# Work Order ID 85827

Item Name: Crosstube Turning Detail

DRAWING NO. D212-664-141	TITLE XTUBE ASSY (205/212/412 HI FWD)	REV. D	DART AEROSPACE LTD ENGINEERING ORDER		D.E.O. NO. D212-664-141-D-1	SHEET NO. SHEET 1 OF 2	SCALE NTS
DRAWN	CHECKED	UP	MFG. APPR.	ER	APPROVED	MP	DE APPR.
DATE 11.04.07	DATE 11.07.11		DATE 11.04.12		DATE 11/04/12		DATE 11.04.12

DRAWING NO. D212-664-141	TITLE CROSSTUBE ASS'Y (205 HI FWD)	REV. D	<b>DART AEROSPACE LTD ENGINEERING ORDER</b>		D.E.O. NO. D212-664-141-D-2	SHEET NO. SHEET 1 OF 1	SCALE NTS
DRAWN <i>UP</i>	CHECKED <i>ASS</i>	MFG. APPR. <i>LB</i>	APPROVED <i>MD</i>		DE APPR. <i>TH</i>		
DATE 11.07.15	DATE 11.07.20	DATE 11.07.21	DATE 11/07/21		DATE 11.07.21

**D212-664-141/-141B  
ASSEMBLY DETAIL**

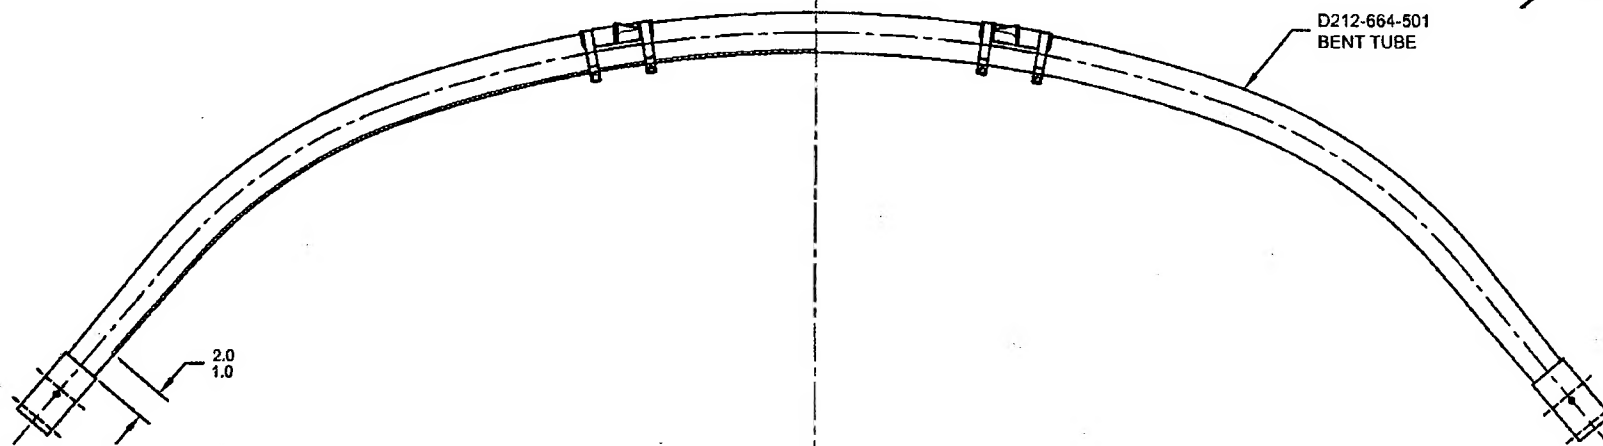
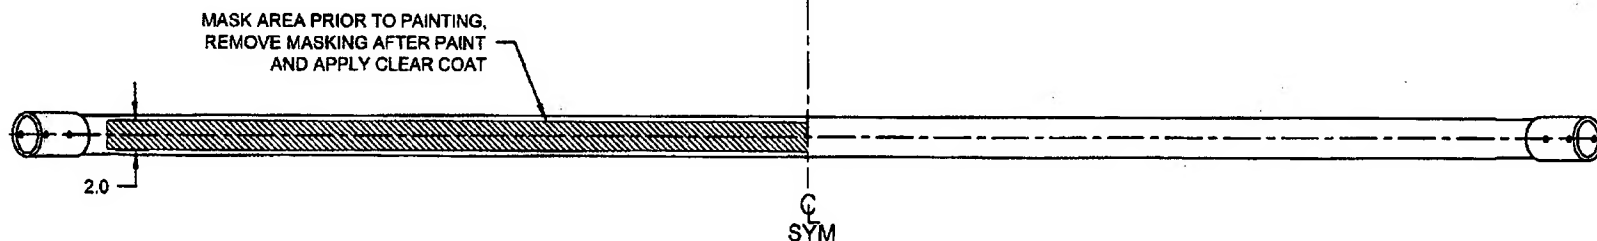
**PURPOSE:**

ADD AN INSPECTION WINDOW TO UNDERSIDE OF CROSSTUBE.

IS:

WAS:
